# **Land East of Junction 11 of the M40, Banbury**

## *Transport Assessment Addendum*

26<sup>th</sup> October 2022  
SJT/RT/23457-06f Transport Assessment Addendum

- 1.5 It is within this context that a Transport Assessment (TA) was prepared which supported a planning application for this development. Oxfordshire County Council (OCC) have commented on this application (ref: 22/01488/OUT) which can be seen in **Appendix B**. This includes a list of transport improvements.

Based upon the ORDNANCE SURVEY MAPS with the permission of THE CONTROLLER OF HER MAJESTY'S STATIONERY OFFICE,  
 © Crown Copyright AL 100030412  
 © David Tucker Associates

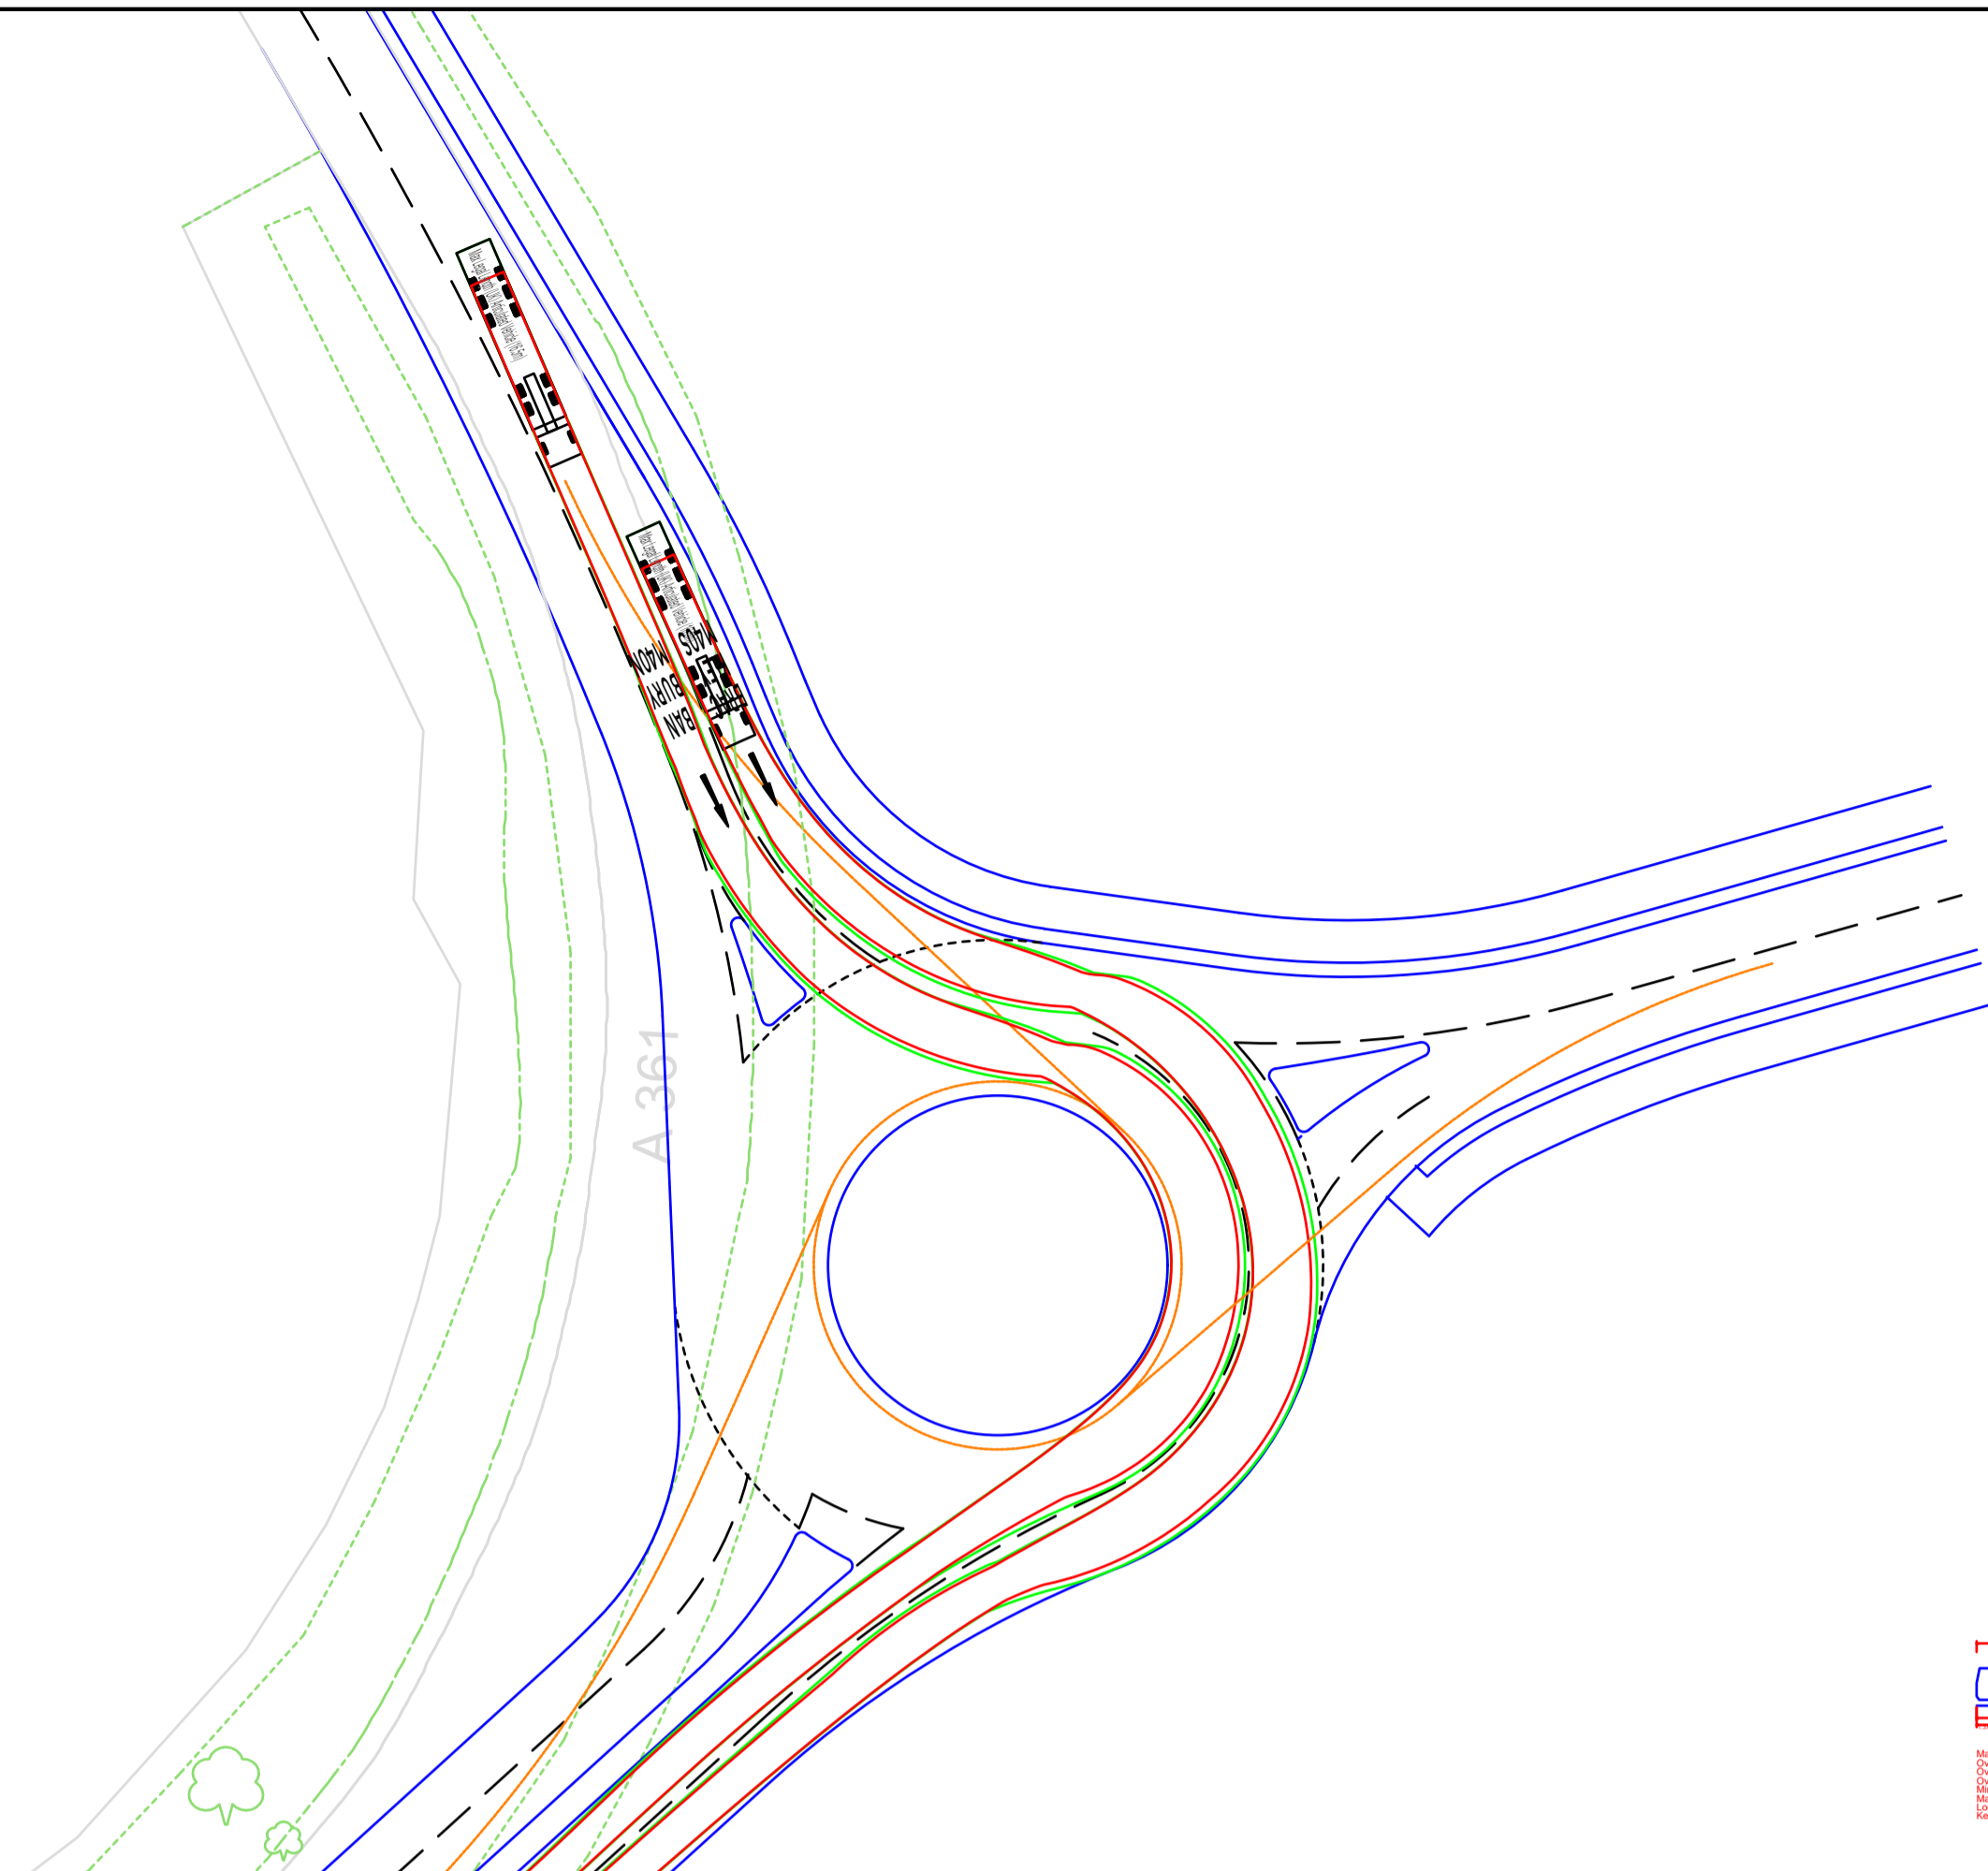
*length of queues and the resulting congestion in the area. It has not been demonstrated in a VISSIM simulation that widening the A361 to two lanes between the proposed and existing roundabouts, and increasing the gyratory entry flare to three lanes, is sufficient to mitigate for the effect of the additional vehicles. Also, it has not been demonstrated that these proposed highway modifications are feasible, considering the level differences between the carriageway and the surrounding land.*

- 9.12 The proposed mitigation will provide an additional entry lane and significantly more stacking space. As can be seen in **Table 5** the performance of the junction is significantly improved and the potential for queuing has significantly reduced relative to the baseline. The mitigation therefore more than offsets the development demand. With respect to an interaction between the junctions, this is unlikely to occur in practice as the layout of the site access provides significant spare capacity to maximise its resilience.

- 9.13 The widening of link between the site access and the adjacent gyratory requires additional land only from within the site boundary and there is no constraint to the ability to provide the required side slopes.
- 9.14 To further improve the performance of the A361 arm, the entry can be signalised. This has been modelled on the basis of two entry lanes (rather than the three that would

Drawing Title  
**ILLUSTRATIVE SITE LAYOUT**

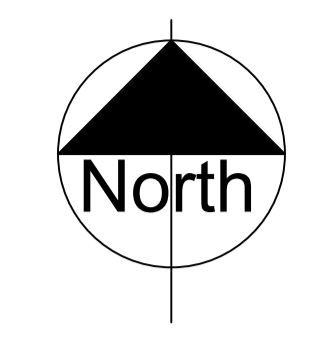
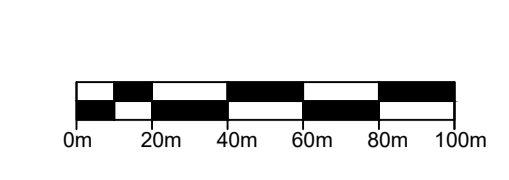
*Final layout of the development will be determined at the Reserved Matters stage. However, the design shown in the Illustrative Site Layout drawing (no. 05001 Rev. P8) is unlikely to be acceptable.*
